# Minnesota United MLS Stadium and Surrounding Mixed-Use Urban Village Alternative Urban Areawide Review (AUAR)

## **FINAL AUAR APPENDICES**

Prepared for the  
City of Saint Paul, MN

July 18, 2016

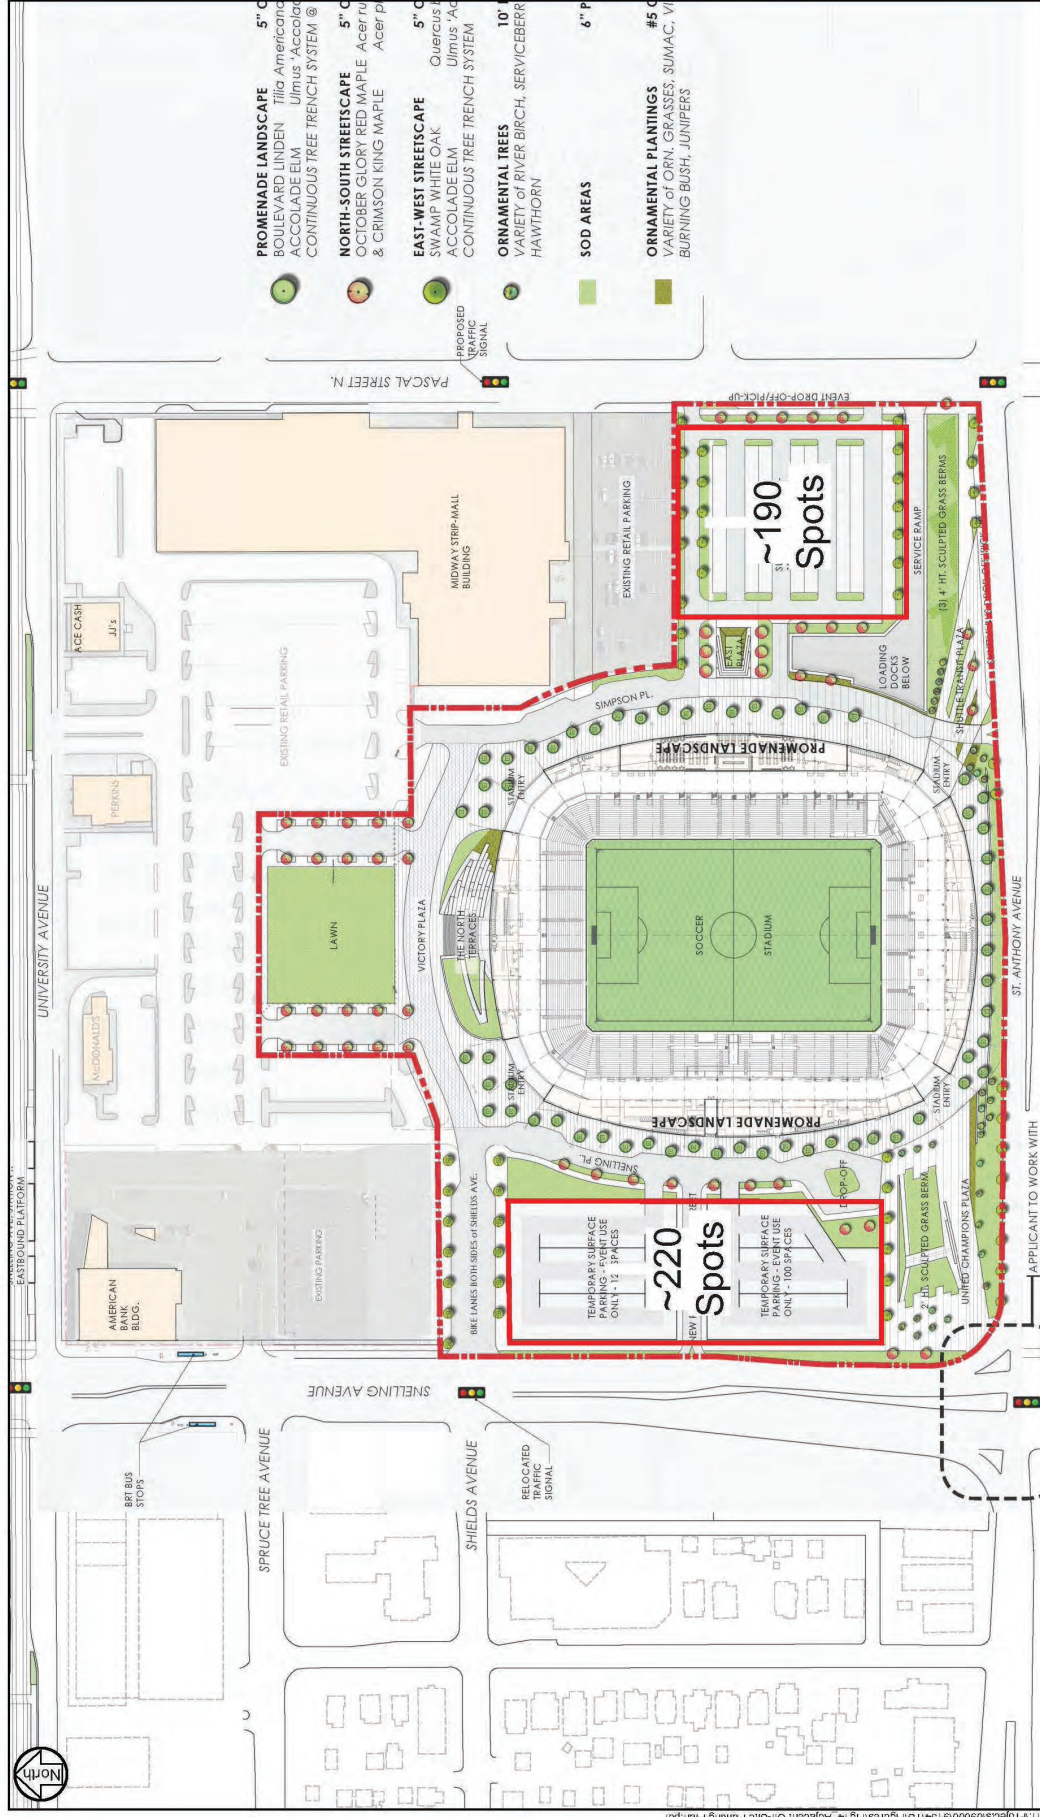
- Figure 18-6 shows 2,900 pedestrians crossing University Avenue to board eastbound LRT, while 3,350 pedestrians crossing at Spruce Tree to board westbound LRT. The AUAR needs to clarify the plans for opening day of the new stadium and final, full build-out of the site.

52. **Comment:** Figure 18-6 shows 2,900 pedestrians crossing University Avenue to board eastbound LRT, while 3,350 pedestrians crossing at Spruce Tree to board westbound LRT. The AUAR needs to clarify the plans for opening day of the new stadium and final, full build-out of the site.
